Agenda Item # 4

SUB-003835-2026

Second Annunciation Greek Orthodox Church
Subdivision

- Subdivision approval to create six (6) legal lots of record from two (2) legal lots of record and one (1) metes-and-bounds parcel.

SUBDIVISION SITE PLAN

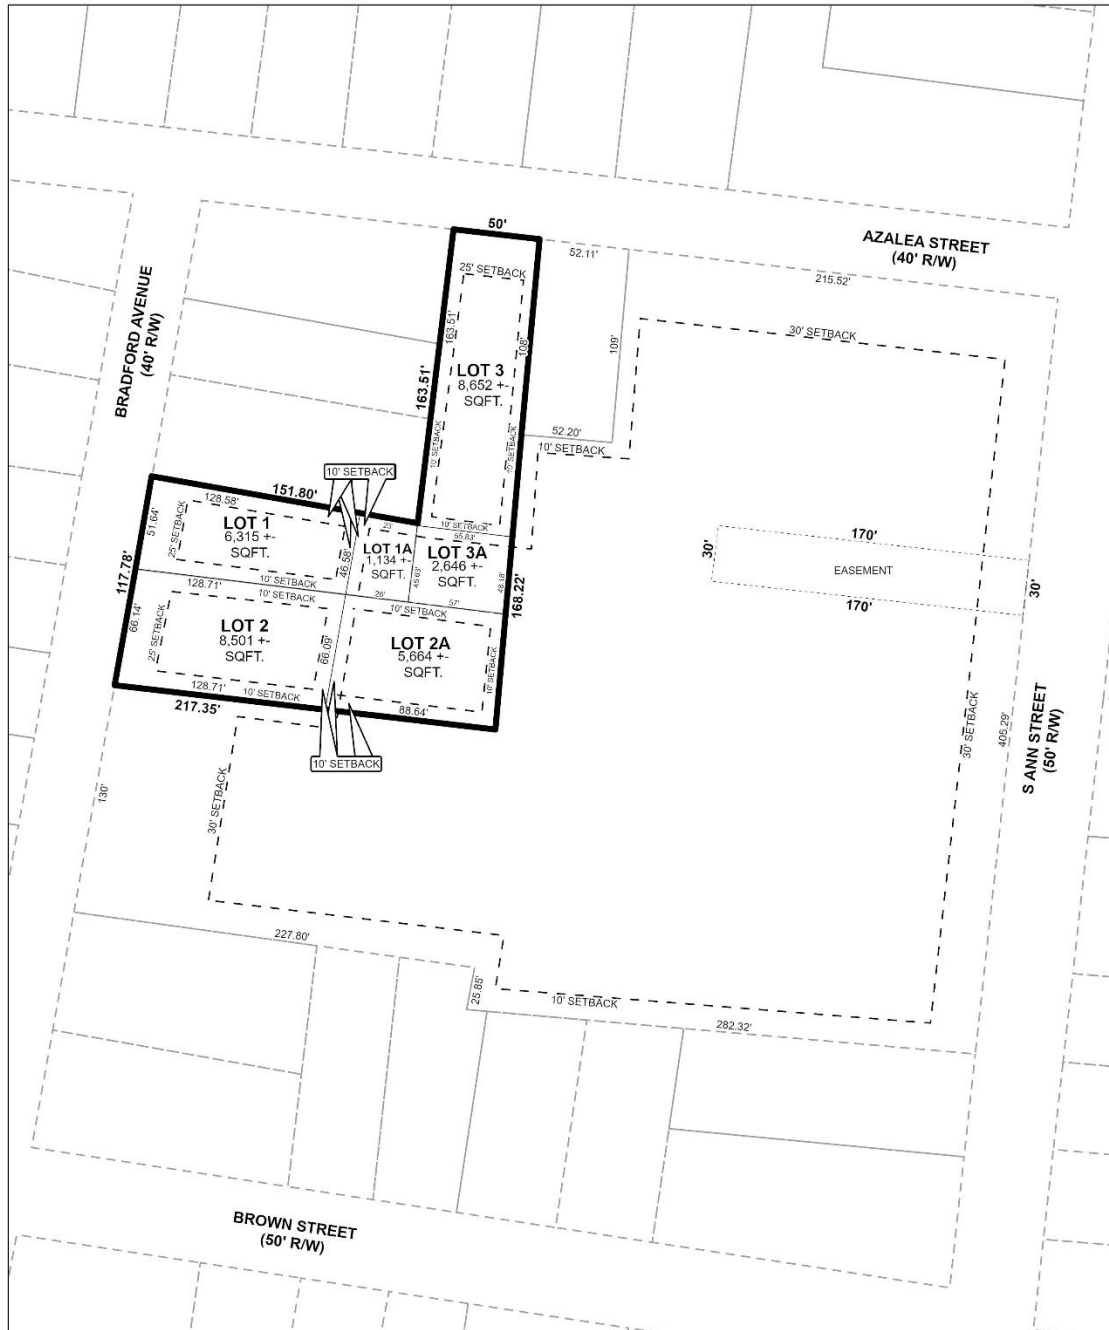
- B. Add Azalea Street and Brown Street to the vicinity map.
- C. Delete "FUTURE SUBDIVISION" label on the adjacent 3.4-acre parcel.
- D. Delete the FLOODPLAIN DEVELOPMENT NOTE. That appears to be applicable to Mobile County subdivisions. It is not required within the city limits.

- E. Delete Sheets 2 and 3 (labeled as SHEET 1 OF 1 and SHEET 1 OF 1) of the three (3) page FINAL PLAT document. A BUILDING OVERLAY drawing (page 2 of 3) and a duplication of the proposed LOT information for proposed LOT 1 and 2 (page 3 of 3) are not applicable to the FINAL PLAT document.

- F. How do LOTS 1 (per SURVEYOR NOTES #1), 1A, 2A, and 3A access a public ROW?
- G. Add a note - A Land Disturbance permit will be required for any land disturbing activity in accordance with Mobile City Code, Chapter 17, Storm Water Management and Flood Control); the City of Mobile, Alabama Flood Plain Management Plan (1984); and, the Rules For Erosion and Sedimentation Control and Storm Water Runoff Control.

Lots 1A, 3A, and 2A do not have access to an abutting street.

Three (3) of the proposed lots within the subdivision would not abut a public street, as required by Section 6.C.4. of the Subdivision Regulations. Instead, these lots are proposed to be incorporated into the adjoining *Third Annunciation Greek Orthodox Church Subdivision*, which is scheduled to be considered concurrently with this

The subdivision has frontage along Azalea Street and Bradford Avenue, both minor streets with curb and gutter; however, both streets have substandard 40-foot rights-of-way. As right-of-way dedications were not required with the approval of the original *Annunciation Greek Orthodox Church Subdivision*, additional right-of-way dedication should not be required with this subdivision. If approved, a waiver of Section 6.B.9. of the Subdivision Regulations will be required. The existing right-of-way labels for Azalea Street and Bradford Avenue should be retained on the Final Plat.

One (1) of the proposed lots would abut Azalea Street, and two (2) would abut Bradford Avenue. All three (3) lots would comply with the minimum lot size requirements for lots in an R-1, Single-Family Residential Urban District. The remaining three (3) proposed lots would be substandard in size, being less than the 6,000-square-foot minimum required for lots in an R-1, Single-Family Residential Urban District pursuant to Section 64-2-5.E. of the UDC and Section 6.C.2.(a)(1) of the Subdivision Regulations. As these three (3) lots are not proposed for development and are intended to be incorporated into the *Third Annunciation Greek Orthodox Church Subdivision*, a waiver of the applicable lot size requirements is recommended. Section 6.C.2.(a)(1) of the Subdivision Regulations authorizes the Planning Commission to waive the applicable lot size requirements. If approved, the lot size labels, in both square feet and acres, shown on the preliminary plat should be retained on the Final Plat, or a table providing the same information should be included on the Final Plat.

Two (2) of the lots proposed to be subdivided contain rental dwelling units that are proposed for removal. These structures must be removed, with all required permits obtained, prior to signing the Final Plat, if approved.

A 25-foot front yard setback is illustrated along the street frontages on the preliminary plat. However, the site is located within the Old Dauphin Way Historic District Overlay, which requires front yard setbacks to be no greater or lesser than the setback of structures located on the same side of the street within 150 feet on either side of the proposed building site, exclusive of the right-of-way. Therefore, the plat should be revised to remove the 25-foot front yard setback. If approved, a note should be placed on the Final Plat stating that the site shall comply with the provisions of the Historic District Overlay (HDO) in Article 14 of the UDC, including the applicable front, rear, and side yard dimensional standards for lots within the HDO.

The preliminary plat also illustrates 10-foot side and rear yard setbacks on the three (3) lots with public street frontage. These setbacks should be removed from the Final Plat, if approved.

1. Approval of the *Third Annunciation Greek Orthodox Church Subdivision* prior to signing the Final Plat;
2. Retention of the right-of-way width labels for Azalea Street and Bradford Avenue on the Final Plat;

3. Retention of the lot size labels, in both square feet and acres, on the Final Plat, or the furnishing of a table on the Final Plat providing the same information;

4. Removal of the two (2) rental dwelling units, with all required permits obtained, prior to signing the Final Plat;
5. Revision of the plat to remove the 25-foot front yard setback lines along the street frontages;

6. Revision of the plat to remove the 10-foot side and rear yard setback lines on the three (3) lots with public street frontage;
7. Placement of a note on the Final Plat stating that the site shall comply with the provisions of the Historic District Overlay (HDO) in Article 14 of the UDC, including the applicable front, rear, and side yard dimensional standards for lots within the HDO;

8. Placement of a note on the Final Plat stating that approval from the Historic Development Department is required prior to the issuance of any development permits;
